# Access Compliance Report

## Public Rights-of-Way

Intersection ID: 9362	Main Street: DELTA_LAKE_DR	Cross Street: ROCKMOOR_RIDGE_RD	Location: SE
ADA ID: 9EDA418B17F7	Ramp Type: PerpDiag	Initial Pass/Fail: Fail	Overall Compliance: No
Severity Score: 10			
Codes/Mitigation Info/Possible Solution		Field Measurements/Component Compliance

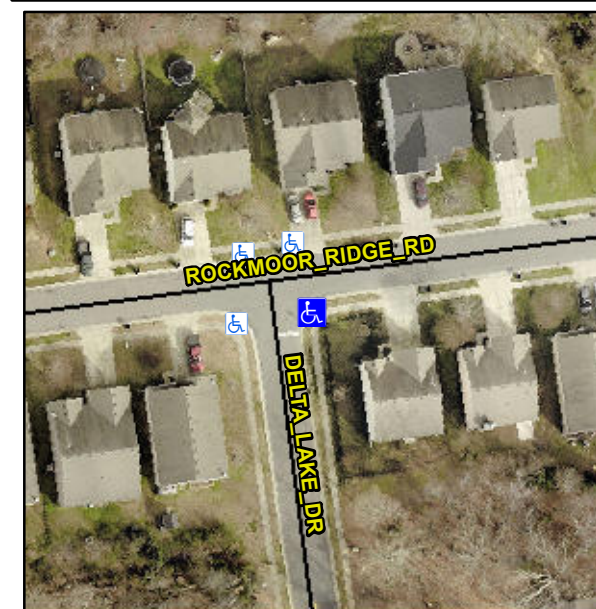
**Not Found, R304.5.1, R304.5.3**

Compliance	Description	Data	Compliance	Description	Data
N/A	Ramp Length (in)	45.5	Yes	Ramp Slope (%)	5.2
No	Ramp Width (in)	47.5	No	Ramp XSlope (%)	4.8
N/A	Flare Type LT	N/A	N/A	Flare Type RT	N/A
N/A	Flare Slope LT (%)	N/A	N/A	Flare Slope RT (%)	N/A
N/A	Flare Traversable LT?	N/A	N/A	Flare Traversable RT?	N/A
N/A	Landing Length (in)	N/A	N/A	DWS Provided?	N/A
N/A	Landing Width (in)	N/A	N/A	DWS Contrast?	N/A
N/A	Landing Slope (%)	N/A	N/A	DWS Length (in)	N/A
N/A	Landing X Slope (%)	N/A	N/A	DWS Full Width?	N/A
N/A	Landing Curb? (Y/N)	N/A	N/A	DWS Offset (in)	N/A
N/A	Shared Landing?	N/A			
N/A	Gutter Ponding?	N/A	N/A	Gutter Slope (%)	N/A
N/A	Gutter Lip Ht (in)	N/A	N/A	Gutter X Slope (%)	N/A
N/A	Painted X Walk1?	No	N/A	Painted X Walk2?	No
	X Walk 1 Direction	To N		X Walk 2 Direction	To W
N/A	X Walk 1 Width (in)	N/A	N/A	X Walk 2 Width (in)	N/A
	X Walk 1 Slope (%)	3.4		X Walk 2 Slope (%)	0.8
	X Walk 1 X Slope (%)	3.3		X Walk 2 X Slope (%)	4.0

N/A	Ramp inside XWalk1?	N/A	N/A	Ramp inside XWalk2?	N/A
	Road Slope (%)	3.4	N/A	Clear Space?	N/A
	Road X Slope (%)	1.1	N/A	Clear Space to XWalk (in)	N/A
N/A	Any Obstructions?	N/A	N/A	Storm Grate/Utility Hazard?	N/A
	Obstruction Type			Storm Grate/Utility Type	
		N/A			N/A
		Yes		Surface Condition? (G/P)	Good

**Remove & Replace Curb Ramp With Two New Directional Ramps or Equivalent.**
